FINAL ENVIRONMENTAL IMPACT REPORT
DEVIL'S GATE RESERVOIR SEDIMENT REMOVAL
AND MANAGEMENT PROJECT
PASADENA, CA
(LOS ANGELES COUNTY)

October 2014

SECTION 8.0 – CLARIFICATIONS AND MODIFICATIONS

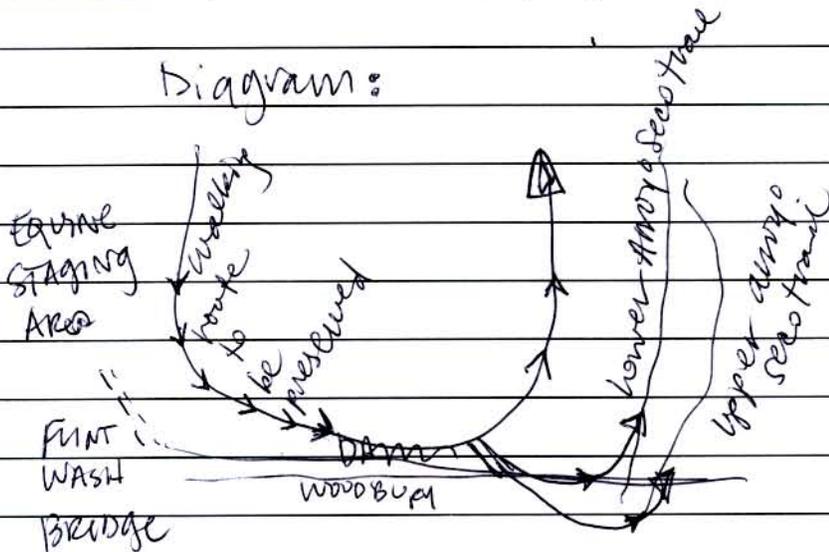
① PLEASE ALLOW USE OF FUNT WASH BRIDGE & TOP OF DAM WALKWAY FOR CONTINUAL FOOT TRAFFIC TO ALLOW THE WALKING/HIKING LOOP TO BE PRESERVED EVEN DURING THE DAILY HAULING TOURS.

IS THERE AN ALTERNATIVE WALKING/HIKING TRAIL PROPOSED TO enable the whole loop to be accessed/Utilized?

Figure 8-27 Graph of Historical Sediment Storage at Devil's Gate Reservoir

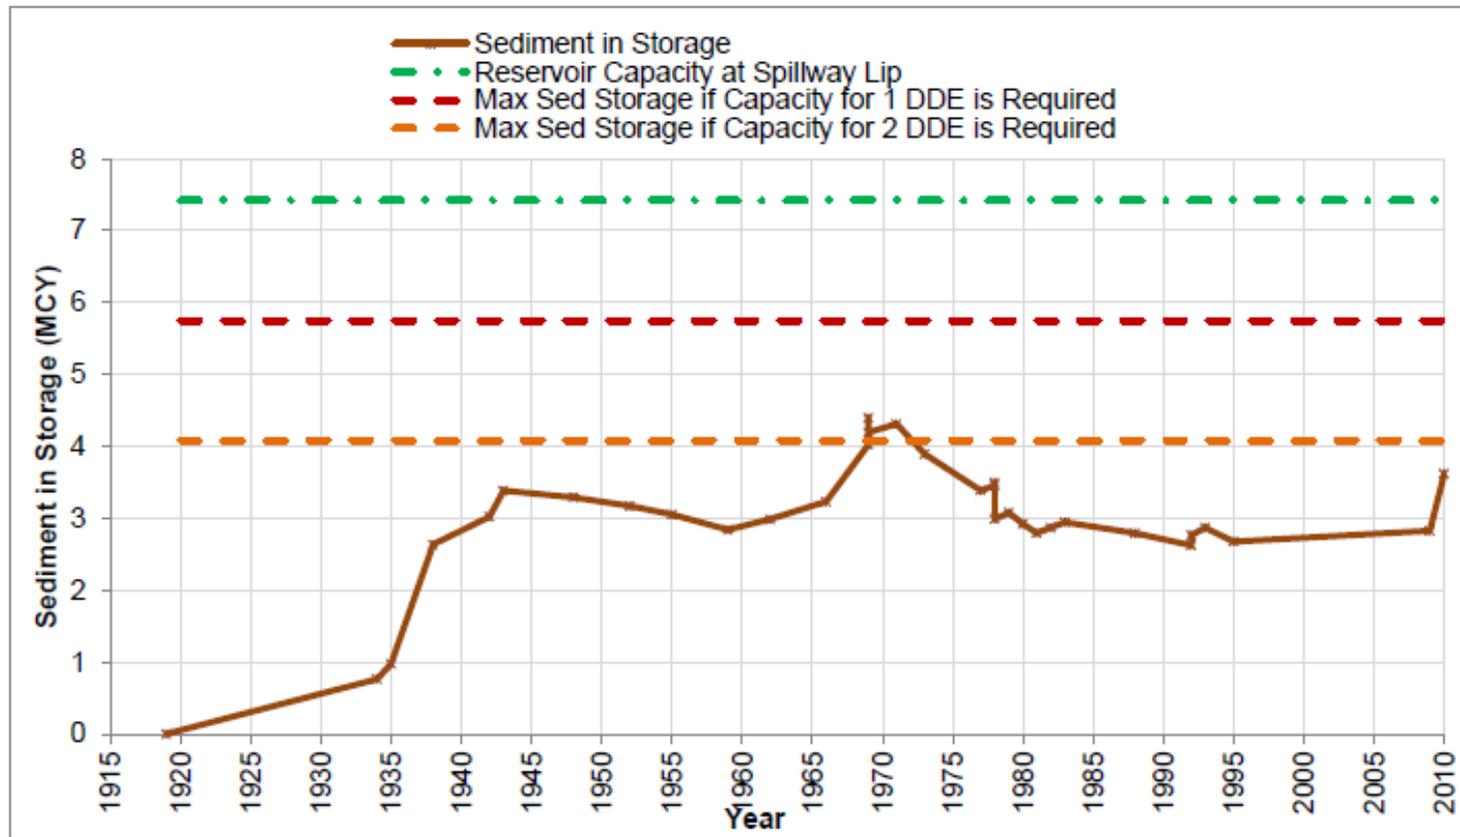
- According to LACDPW Sediment Management Strategic Plan 2012-2032 (<http://dpw.lacounty.gov/lacfd/sediment/stplan.aspx>), Table 2-1 Reservoirs in the Flood Control District (Exhibit 4), the remaining capacity is 3.7 mcy (47%), almost 2 Design Debris Events (DDEs). In addition, the Strategic Plan Figure 8-27, Graph of

Exhibit 11 – Hahamongna Watershed Park Master Plan – Trail Plan Ex. 3-8

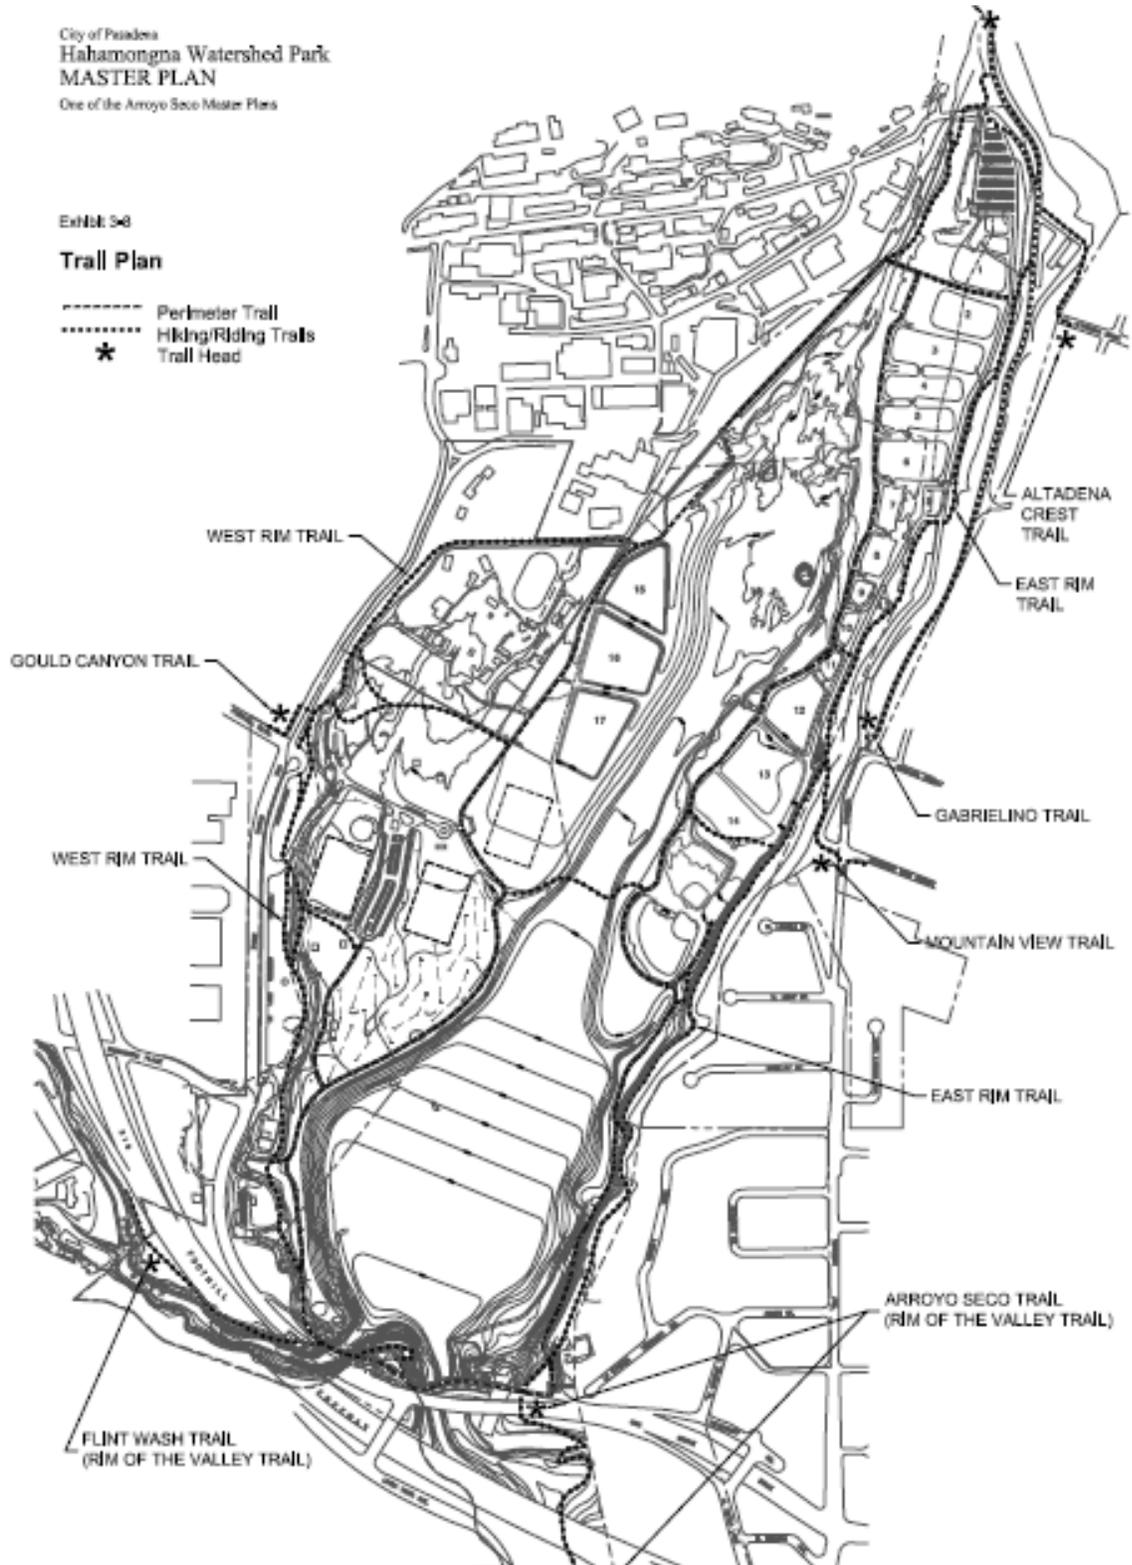
B. The trails map in the DEIR, Figure 3.15-2 Devil’s Gate Area Designated Trails, is drawn incorrectly. It does not correspond with either the trail alignments shown in the trail plan adopted in the HWP Master Plan or the existing Hahamongna trails as shown on the City of Pasadena Arroyo Seco Guide to Public Trails and Recreation, revised 3/23/2010 (Exhibit 12).

Figure 3.15-2: Devil's Gate Area Designated Trails depicts the existing trails within the reservoir. This figure is based on the City of Pasadena Department of Public Works' Arroyo Seco Trail Map.

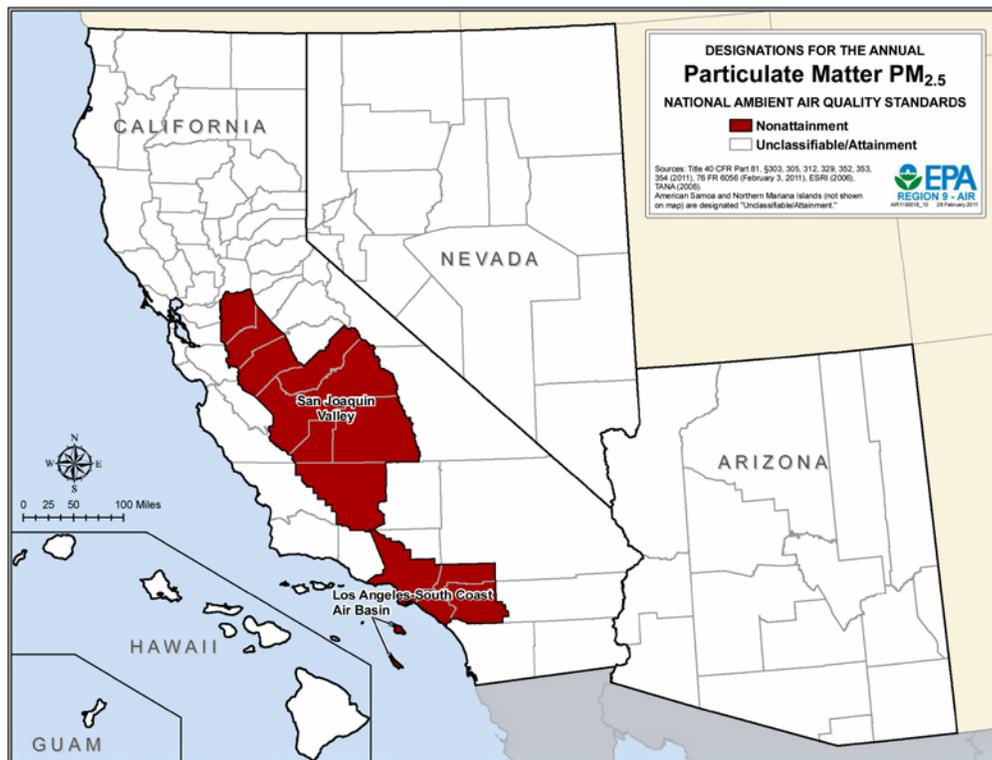
Note 2 Idling trucks must be considered because these double dump trucks will be unloaded much more rapidly than they can be filled; idling produces significant emissions that are not included in the DEIR calculations. These extra

emissions will affect those nearest to the Hahamongna site. That's why we need real pollution measurements in addition to predictions of pollutants.
